Proposed Site Access, Hemingfield Road, Barnsley

Stage 1 Road Safety Audit

HARGREAVES LAND LTD

Ref: 23-160-005.01

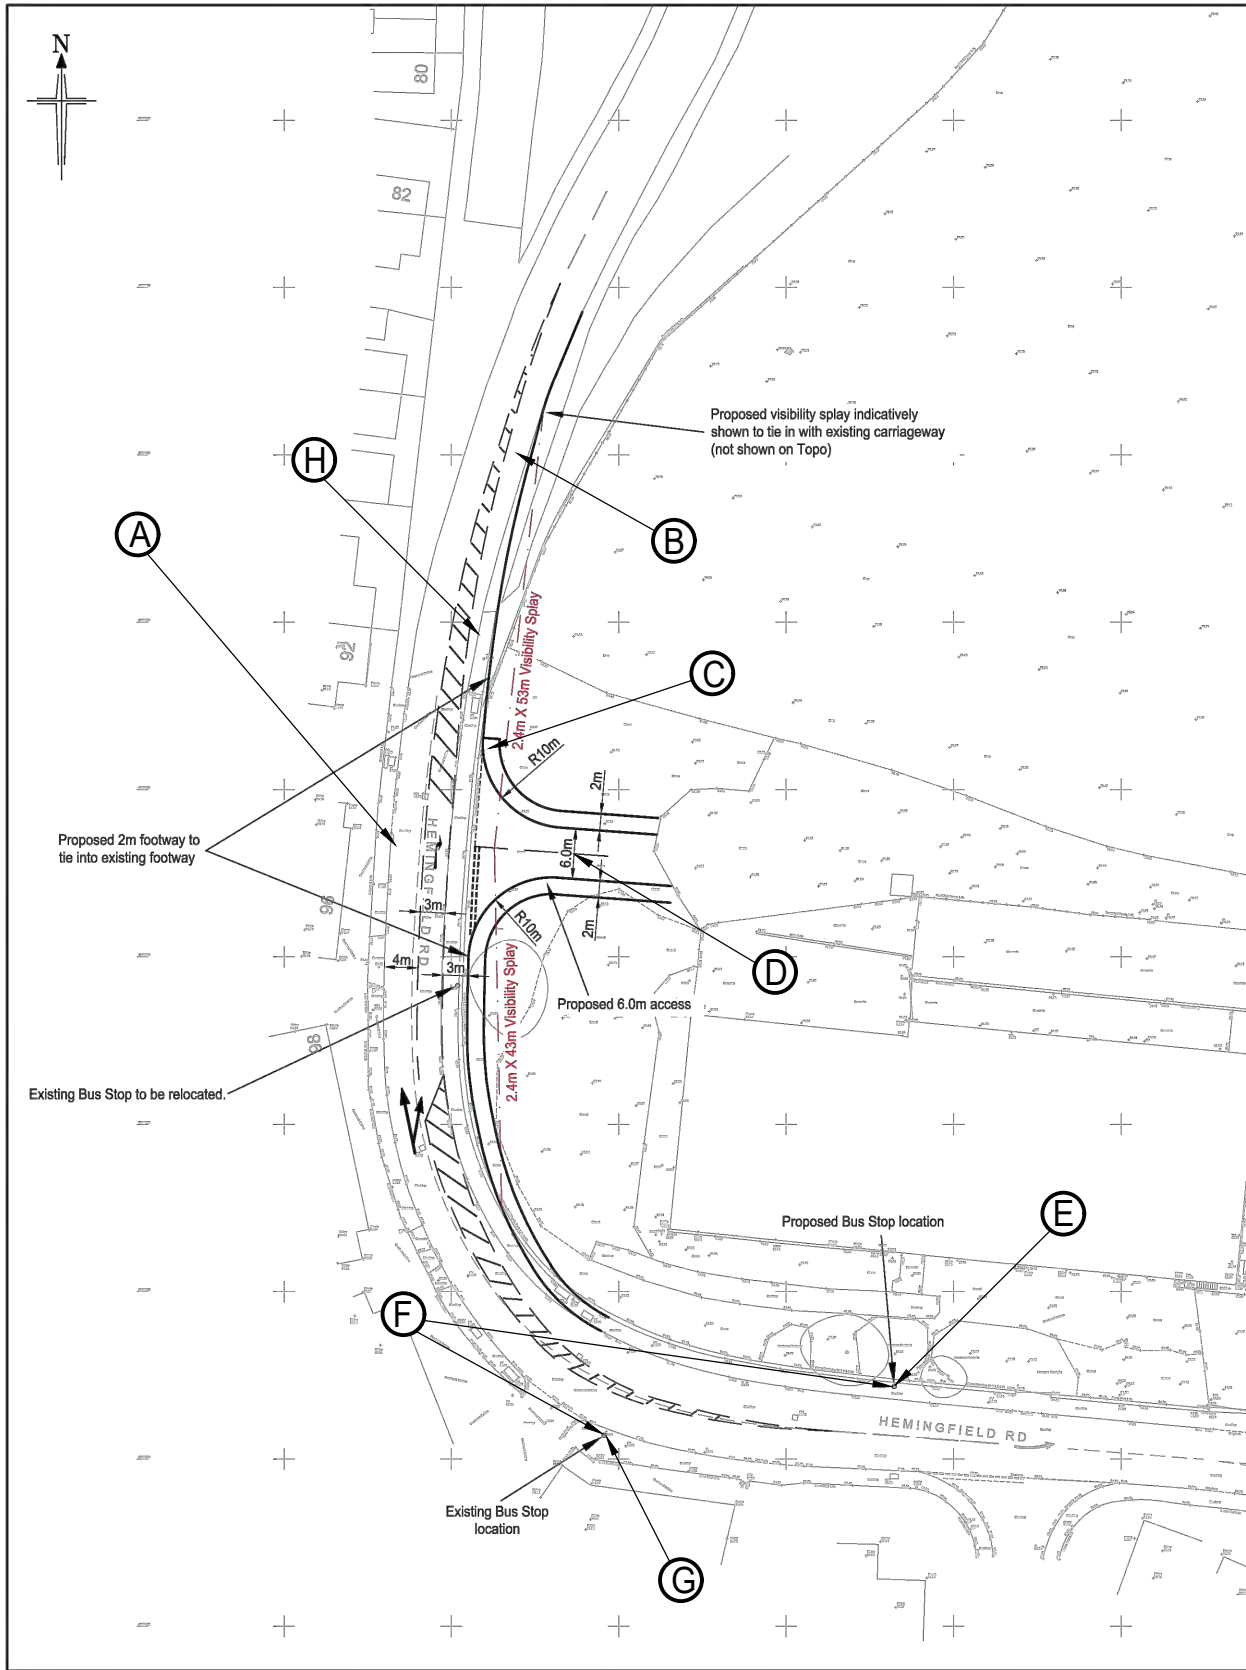
2.2 **Problem A**

Parking on western side of Hemingfield Road opposite the proposed site access.

Vehicles parked on the western side of Hemingfield Road will restrict turning movements into and out of the access and northbound through movements on Hemingfield Road, increasing the risk of rear end shunt type collisions and collisions as vehicles leave the site.

Problem B

Available Stopping Sight Distance to the junction for drivers approaching southbound on Hemingfield Road is restricted by existing vegetation

Problem C

There is no pedestrian crossing facility to the north of the proposed access. The lack of dropped kerbs and tactile paving increases the risk of trips and falls as pedestrians attempt to cross the carriageway to travel to and from the north of the site on the western side of Hemingfield Road.

Problem D

The site access junction does not include facilities to allow pedestrians to cross the minor arm of the junction. The lack of dropped kerbs and tactile paving increases the risk of trips and falls as pedestrians attempt to cross the carriageway of the minor road to travel north on the eastern side of Hemingfield Road.

Problem E

Forward visibility to the proposed relocated bus stop to the south of the scheme on Hemingfield Road may be restricted by the proposed development and will increase the risk of rear end shunt type collisions or loss of control type collisions between southbound vehicles and stationary buses at the bus stop.

Problem F

The existing and proposed bus stop locations to the south of the proposed access on Hemingfield Road do not include raised kerbs to assist with access to buses and increases the risk of injury as passengers board and alight from buses.

Problem G

There are no pedestrian crossing facilities between the development site and the existing bus stop to the south west of the proposed development on the southern side of Hemingfield Road. The lack of dropped kerbs and tactile paving increases the risk of trips and falls as pedestrians attempt to cross the carriageway and access the existing bus stop. The carriageway widening to facilitate the right turn lane will also make it more difficult for pedestrians to cross Hemingfield Road.

Problem H

The proposed southbound through lane width is 3.0 metres, this may not be wide enough for buses and HGV's to pass through at 30 mph without encroaching on the right turn lane associated with the proposed access leading to head on collisions.

It is recommended that measures to ensure that parking does not restrict carriageway width opposite the proposed side road are provided.

Provide sufficient stopping sight distance on approach to the proposed new junction from the north.

It is recommended that tactile paving and dropped kerbs are provided at a suitable location to the north of the proposed access and that appropriate intervisibility is provided between the crossing location and oncoming vehicles.

It is recommended that tactile paving and dropped kerbs are provided at a suitable location on the desire line across the minor arm of the proposed junction.

It is recommended that forward visibility between drivers on the southbound carriageway of Hemingfield Road and the relocated bus stop is reviewed and measures are provided to ensure that the visibility envelope remains clear of obstruction.

It is recommended that the existing and proposed bus stops are provided with raised kerbs in line with the Disability Discrimination Act.

It is recommended that a crossing facility for pedestrians is provided across Hemingfield Road.

It is recommended the southbound movement through the junction is assessed further to ensure that large vehicles including buses can pass through the junction safely without encroaching on the right turn pocket associated with the proposed access.
